REFERRAL REPORT

TO: Vancouver City Council
FROM: General Manager of Planning, Urban Design and Sustainability
SUBJECT: CD-1 Rezoning: 3304 Kingsway

This report evaluates an application to rezone 3304 Kingsway from C-2 (Commercial) District to CD-1 (Comprehensive Development) District to permit a density of 3.93 FSR and building height of 24 m (78.7 ft.), under the *Secured Rental Policy* (“SRP”). The proposal is for a six-storey, mixed-use building with a total of 79 secured market rental housing units and commercial use at-grade.

Parking Level One

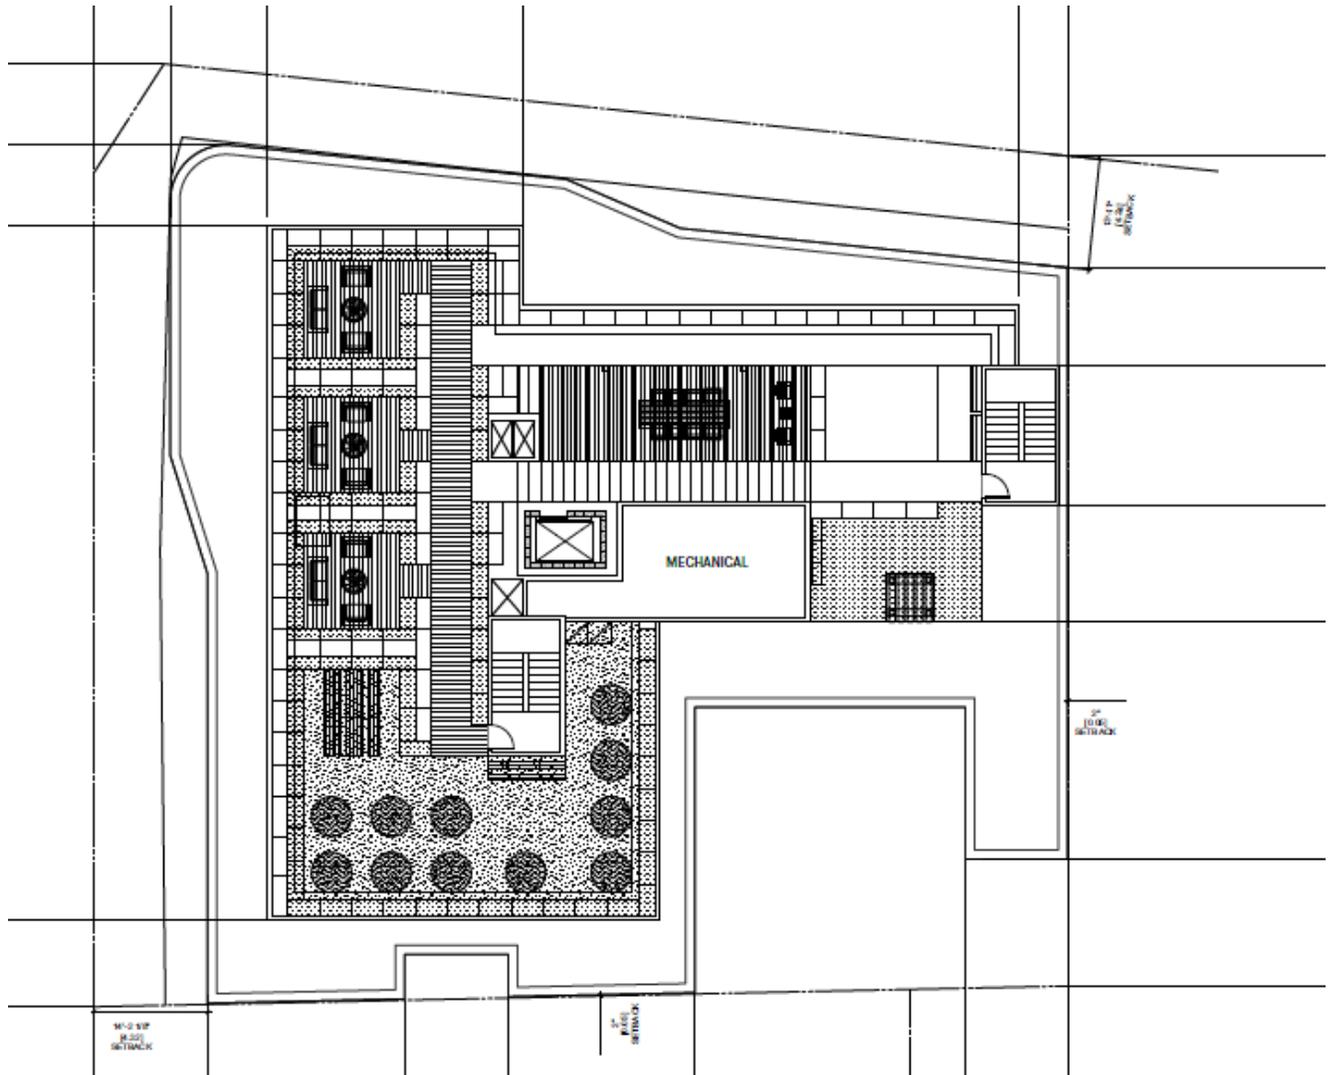
- (b) Provision of 21'8" maneuver aisle width or additional stall width. Refer to V2 to R3.
- (c) Provision of improved interface of the parkade access and the lane.
 - i. Improve sightlines for the main parkade ramp at the lane and the Class B loading bay.
- (d) Provision of review of the parking and loading design considering vehicle and truck turning movements and show vehicle turning swaths considering:
 - i. Largest anticipated design vehicles and loading vehicles;
 - ii. Two-way flow at the top of the ramp and the lane, the full length of the ramp, the bottom of the main ramp and the maneuvering aisles through the parkade; and
 - iii. Loading to and from the lane.

Note to Applicant: Show all at grade structure and utilities on the maneuver diagrams at the lane.

South Elevation

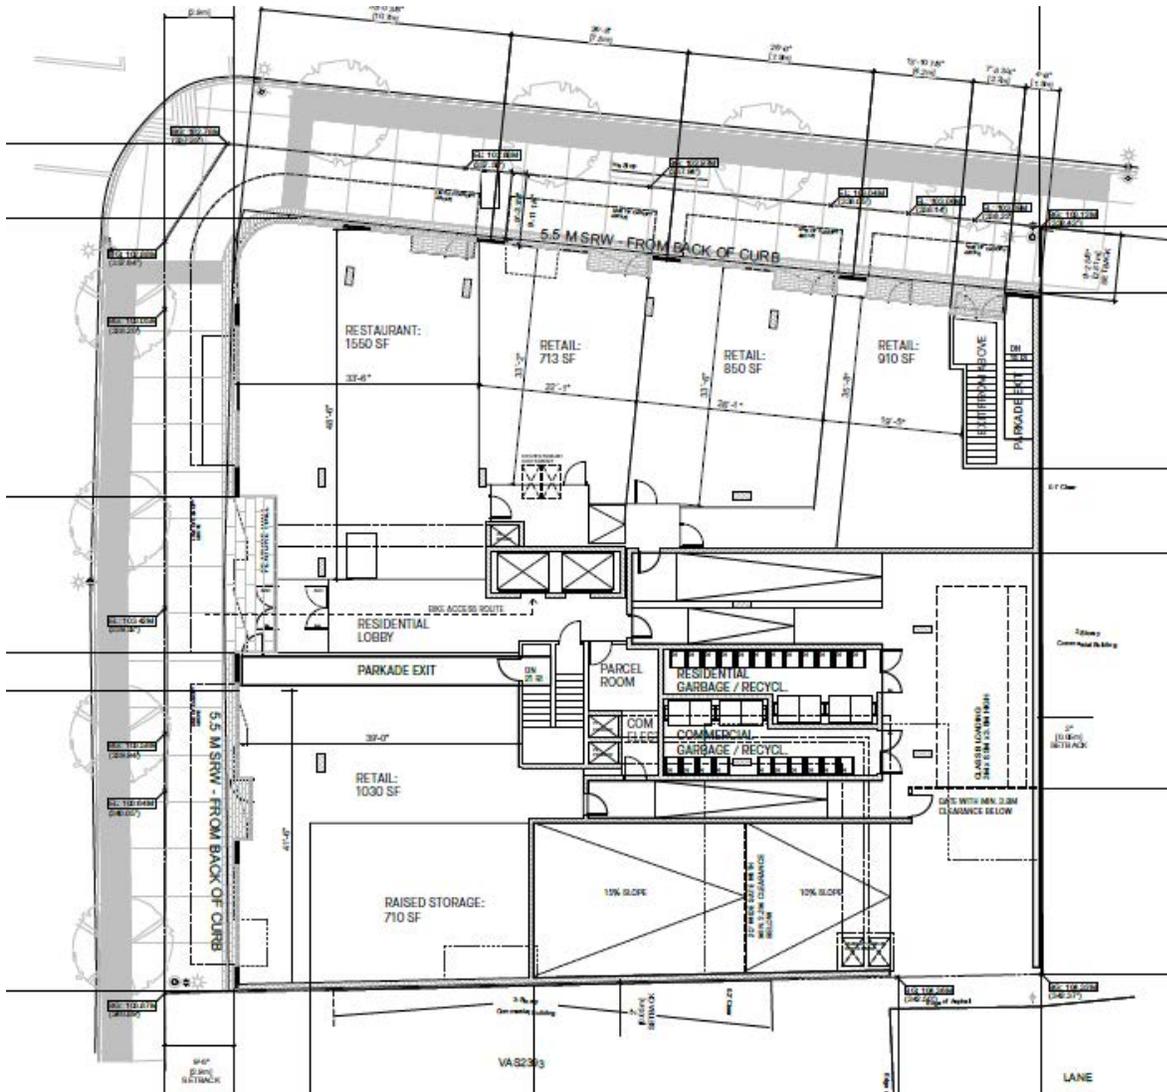
- 1.44 Architectural drawings: Elevations along property line do not match City supplied building grades. Revise to ensure City building grades are met. To minimize grade differences, interpolate a continuous building grade between the points given on the City supplied plan.
